Case File Number: DA06011, PUD06010, PUD06010-PUDF07 and -8

Proposal: Two Final Development Permits (FDPs) for approx. 20 acres of

The purpose of this report is to recommend approval of two Final Development Permits for all remaining Brooklyn Basin parks (including Gateway, South and Channel Parks). The Design Review Committee of the Planning Commission (DRC) reviewed the project on October 25, 2017. The Brooklyn Basin Planned Unit Development (PUD) was approved in 2009 with 30 acres of public parks to be located along the waterfront of the Oakland Estuary. The 10-acre Shoreline Park was the first Brooklyn Basin Park to receive FDP approval in 2016, and is currently under construction in the southeast portion of the Brooklyn Basin site. At this time, the Brooklyn Basin master developer, Zarsion-OHP 1, LLC (ZOHP), has submitted schematic design for the remaining 20 acres of planned parks and seeks approval of FDPs by the Planning Commission. The two proposed Final Development Permits are required to construct the remaining planned parks. The proposals are generally consistent with and a refinement and evolution of the conceptual design included in the 2009 approved Brooklyn Basin

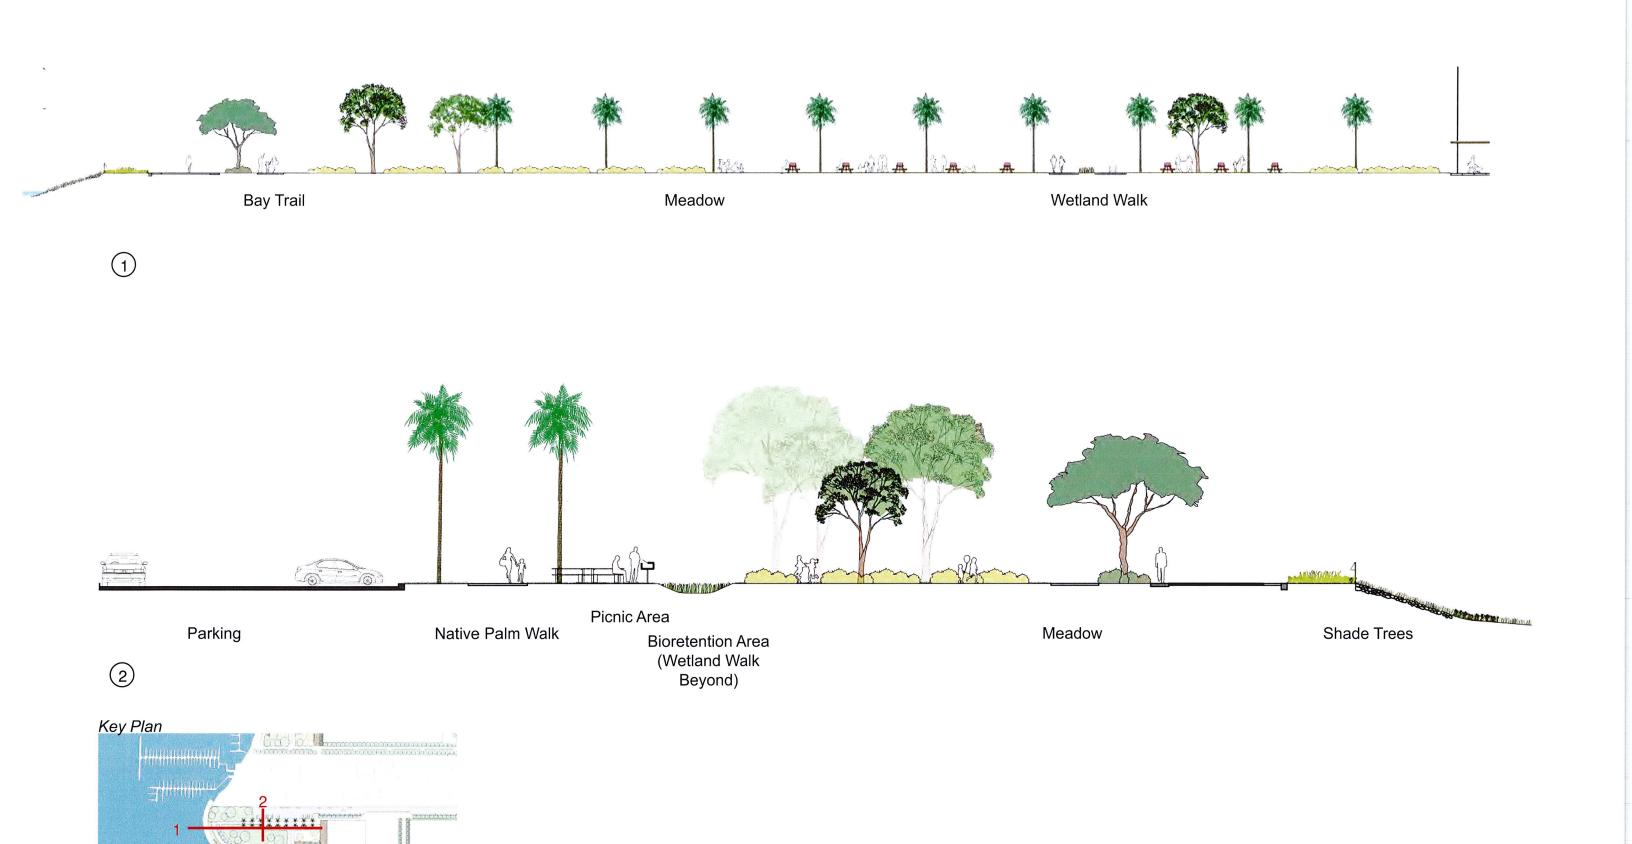
CALM letter dated 10/24/2017	8	We question the rows of trees near the Bay Trail at "South Meadow" on sheet L8.0 and at the seaward edge of "Viewing Hill" on L17.0. What are these? Why are they there? Should they be low native shrubs and marsh-compatible plants instead? This is an open waterfront area, and longtime volunteers associated with coastal clean-up and rehabilitation have been encouraging native plants and compatible species. Without knowing what plants are proposed it is difficult to comment, but it seems unwise to plant rows of trees in these two locations. Wouldn't they block views, as well as being inconsistent with exposed water-edge bay trail conditions? Or would these trees provide useful shade and withstand the wind and weather at that location?	studied. In our preliminary public meetings there was concern that we are not using enough trees and	We will take into consideration the site conditions, both historic and current, to propose trees that will thrive on the site and provide necessary amenities for both people and wildlife.

Flexible Parking + Event Space

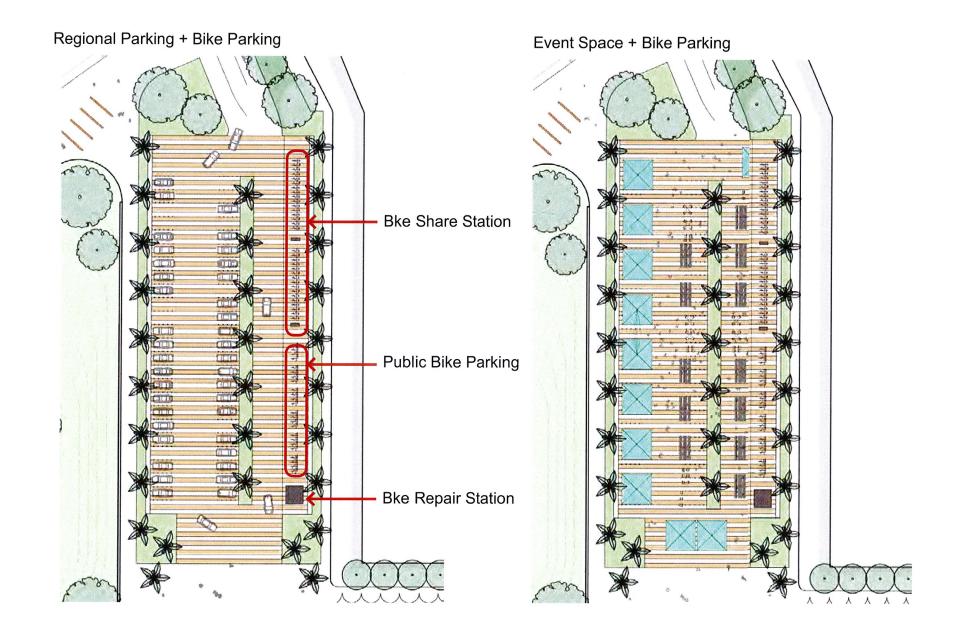
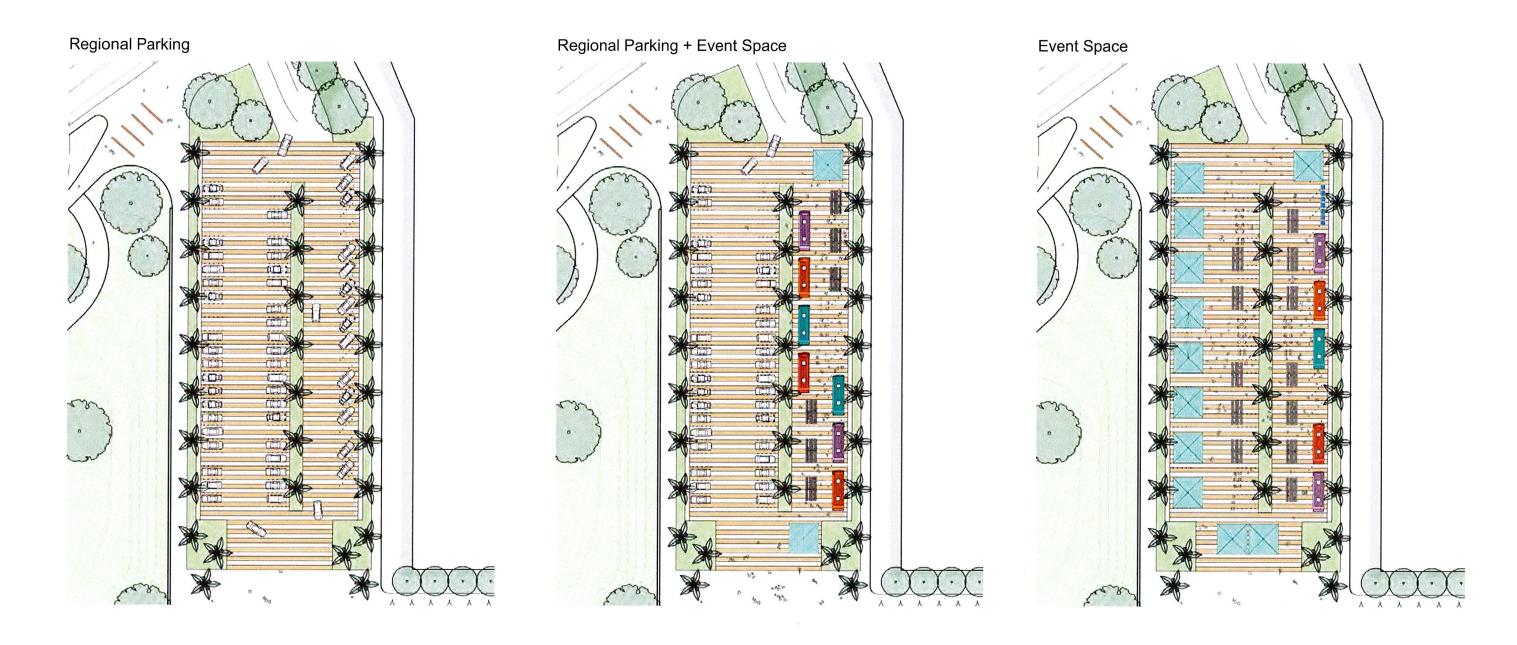
CALM letter dated 10/24/2017	11	In "Channel Park" could the paving for the flexible arrival court/event space/flex space (sheets 17.0, 20.0, 27.0, 29.0) be permeable rather than asphalt? Since food trucks are contemplated, install power hookups to avoid the presence of multiple small, polluting, and noisy diesel generators. Perhaps outlets and hookups for event arrangements should be provided, too? Portable generators should be avoided.	Paving for the flexible arrival court is still being studied. We will consider permeable options. Power hookups are planned.	We will research options for permeable pavers and study overall performance requirements for pavement.
CALM letter dated 10/24/2017	12	We question the use of cobblestones shown along the concrete "boardwalk" on L30.0; this could present serious mobility and access problems for people using canes, walkers, strollers, or wheelchairs to approach the railing at the water edge.	All cobble pavements will be ADA accessible.	Detail for ADA compliant cobbles we have used before will be provided in the permit set.
